STAFF REPORT
COMMUNITY DEVELOPMENT DEPARTMENT

HEARING DATE: June 6, 2024
 TO: Planning & Zoning Commission
 FROM: Stacy Hersh, Associate Planner
 208-884-5533
 SUBJECT: The Gateway at Ten Mile PP, CUP
[H-2024-0010](#)
 LOCATION: NEC of W. Franklin Rd. & N. Ten Mile Rd., in the West ½ of the SW ¼ of Section 11, Township 3N., Range 1W. (Parcel: S1211336065)

Preliminary plat (PP) consisting of 31 buildable lots 3 common lots on 38.99+/- acres of land zoned C-G and R-40 for The Gateway at Ten Mile; and a Conditional use permit (CUP) for a multi-family development containing a total of 390 residential dwelling units in the R-40 zoning district.

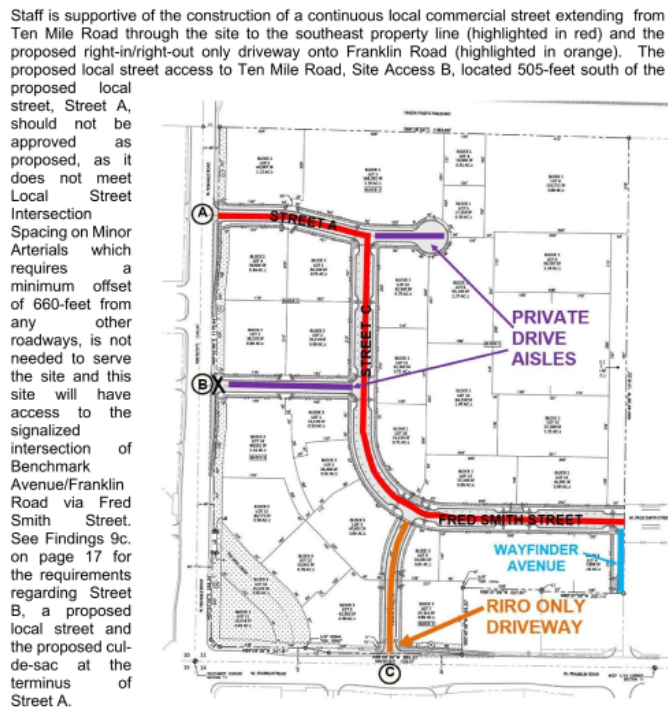
Two (2) access driveways are proposed via W. Franklin Rd. – one (1) right-in/right-out only (Private Street A), 565-feet east of Ten Mile Rd. and one (1) full-access, east of Ten Mile Rd. (Wayfinder Avenue -future collector to be built). Upon dedication of the required right of way by third parties, the Applicant shall construct half plus twelve feet of the future collector street adjacent to the property's southeast corner, as shown on the preliminary plat. ***The City supports the additional access to Franklin Road because the completion of the collector roadway is contingent upon the owners of the adjacent properties to the southeast (parcels S1211336300 & S1211336401) ACHD has approved the full access for the future collector to be built as a full access and the right-in/right-out only as proposed***

with Private Street A. Staff recommends depicting Private Street A as a drive aisle on the plat because it does not meet the private street standards outlined in UDC 11-3F-4.

- h. Remove Public Street B from the plat limiting the number of access points on a busy arterial street near the intersection per UDC 11-3A-3.
 - i. Depict a cross-access easement on Lots 3 – 9, Block 3 for the right-in/right-out drive aisle on the plat.

D. Pedestrian & Bicycle Circulation Plan

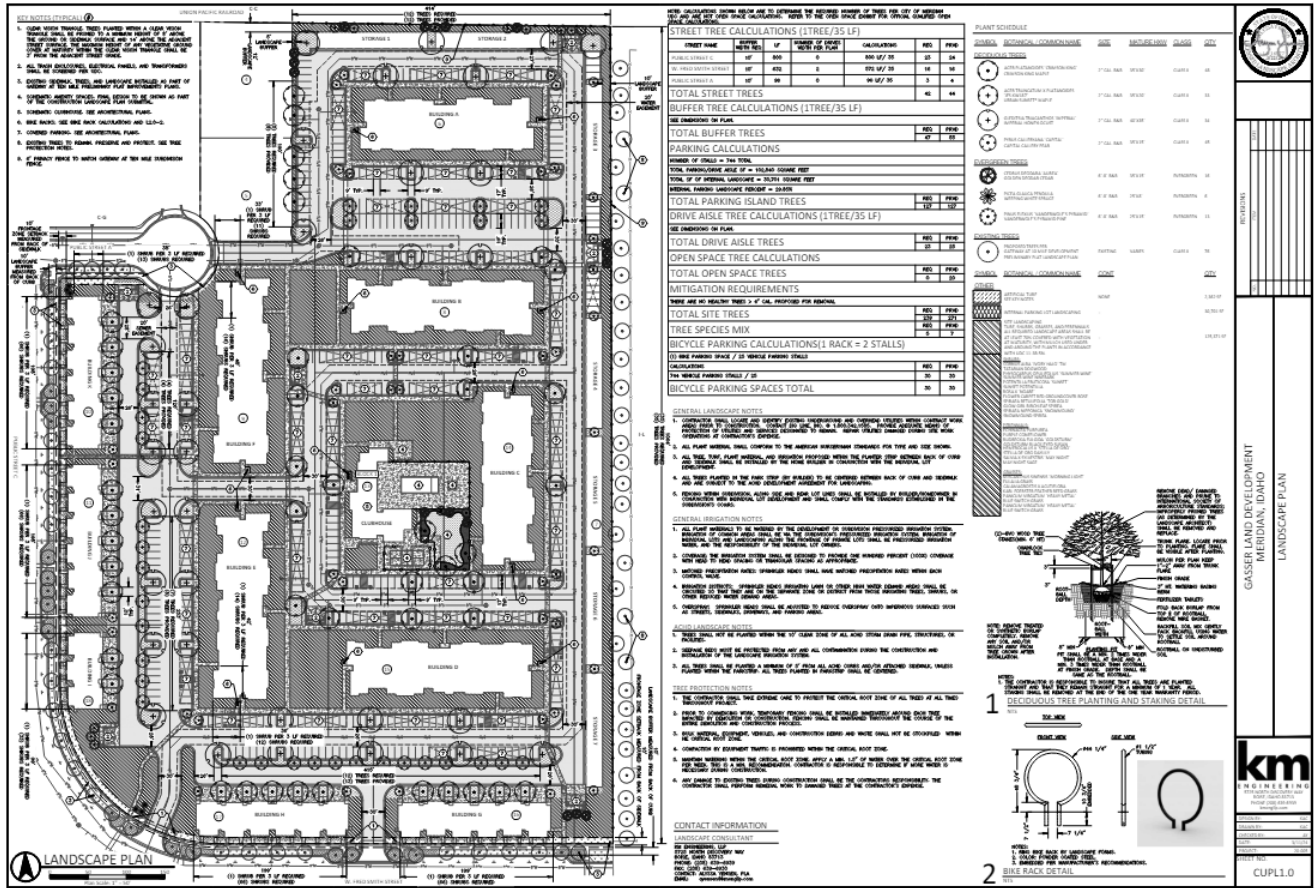
The Applicant is proposing what appears to be 6-foot wide sidewalks along both sides of W. Fred Smith Street and Public Street C. **Staff recommends that the Applicant construct 10-foot wide detached pathways along both sides of these streets in accordance with ACHD's adopted Livable Street Performance Measures and UDC 11-3A-5.**

West Ada School District (WASD) recommends the addition of a micro-path from the plaza area between Street A and Street B to the sidewalk along Ten Mile Road. This location would be a prime location for a bus stop.

F. Landscape Plan for Multi-Family Portion of Development (date: 03/11/2024)

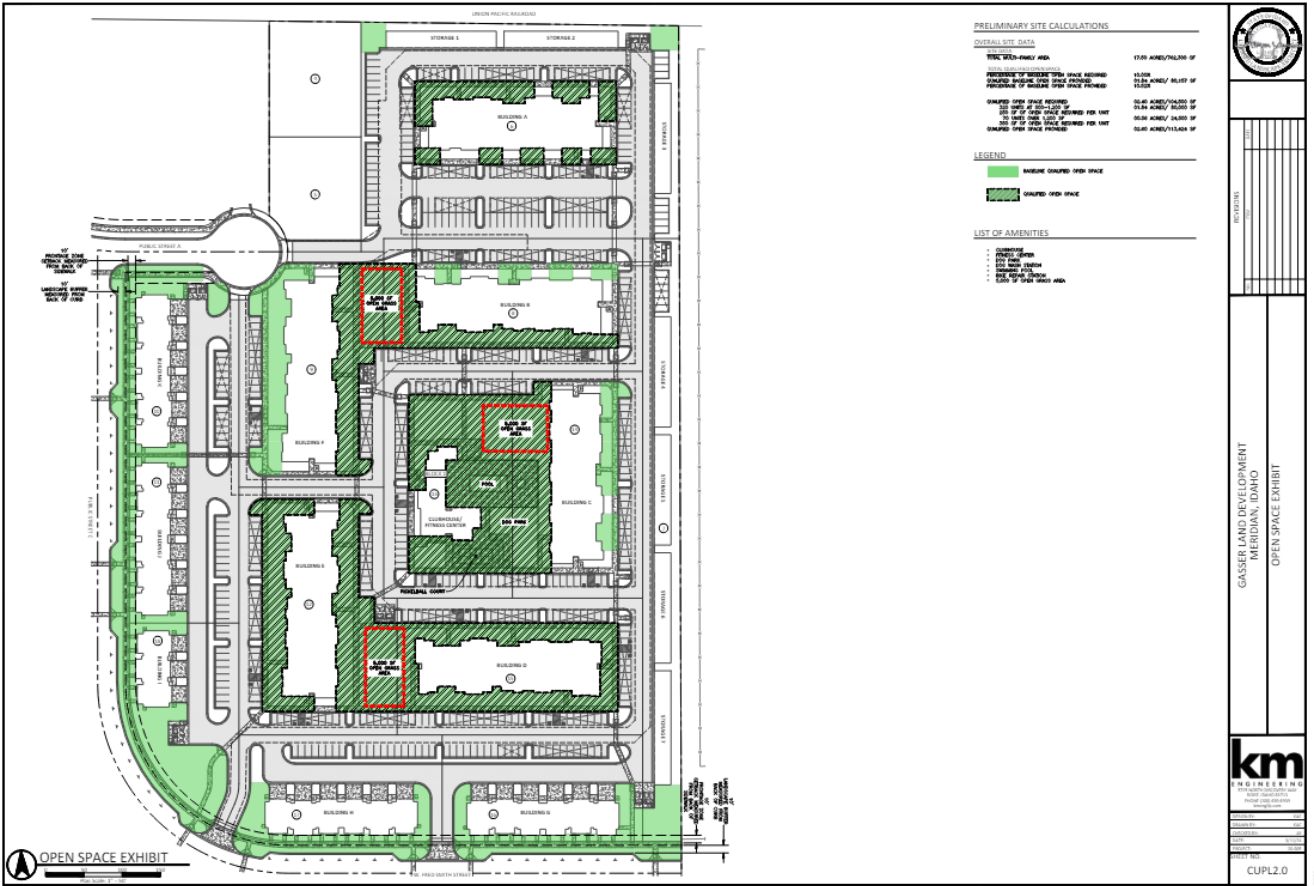
The number of trees proposed in buffers meets the minimum standard required by UDC 11-3B-7; however, the TMISAP requires an enhanced street buffer to align with the TM Center Subdivision directly to the south. (refer to figure below). Furthermore, Staff finds that the Applicant should enhance the landscaping around the Ten Mile Creek on Lot 10, Block 3 to create an attractive linear open space for the development.

A calculations table is included on the landscape plan submitted with this application demonstrating compliance with the above standards; however, Staff recommends that the applicant enhance the street buffers in accordance with the TMISAP guidelines (pages 3-26, 3-27, 3-28, 3-29 & 3-30.

- b. Include a detail of the proposed fencing at the time of CZC submittal.
 - c. Depict a minimum 5-foot wide detached sidewalk along S. Ten Mile Rd. in accord with UDC [11-3A-17A](#).
